MECKLENBURG COUNTY
Land Use & Environmental Services Agency

MEMORANDUM

Subject: Rezoning Petition Comments

2024-146: Panthers Stadium Rezoning

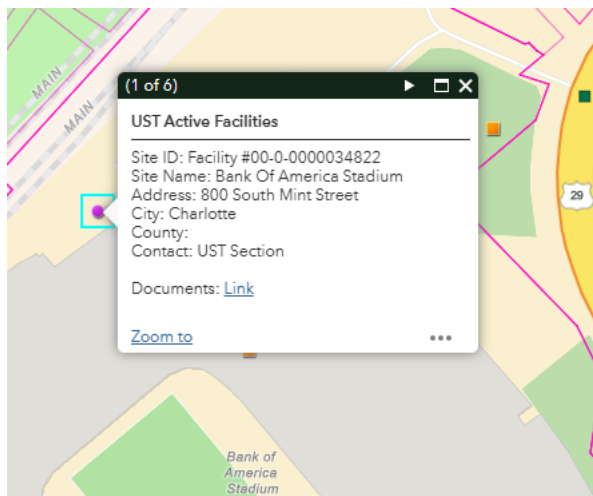
Contamination sites exist on the property and in the vicinity, so there may be restrictions for water supply wells and land use. Underground storage tanks may exist at the property.

Groundwater & Wastewater Services records indicate contamination site(s) exist on or within 1,500 feet of the properties included in the petition. An established Area of Regulated Groundwater Usage (ARGU) as defined by the Mecklenburg County Groundwater Well Regulations extends 1,500 feet around the contamination sites. In an ARGU where municipally supplied water is available water supply wells for potable water supply, irrigation or open loop geothermal systems may not be permitted or constructed on or within 1,000 feet of contamination sites. Wells may be permitted with special construction and sampling requirements between 1,000 and 1,500 feet of contamination sites.

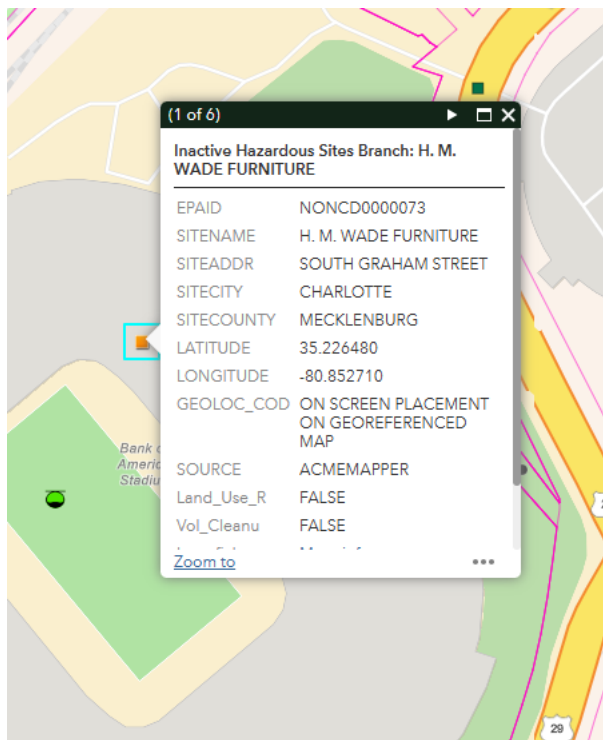
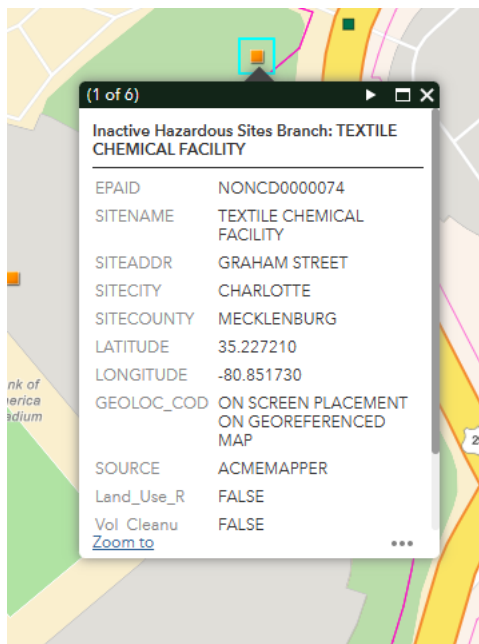
At least four NCDEQ UST incidents and one active UST facility are listed at this property. Any existing tank and its contents should be removed, following applicable NCDEQ guidance, prior to any demolition or grading activity. GWS recommends contacting Ron Taraban w NCDEQ at ron.taraban@deq.nc.gov for more info.

At least two NCDEQ IHSB sites are listed at this property. GWS recommends contacting Collin Day w NCDEQ at collin.day@deq.nc.gov for more info.
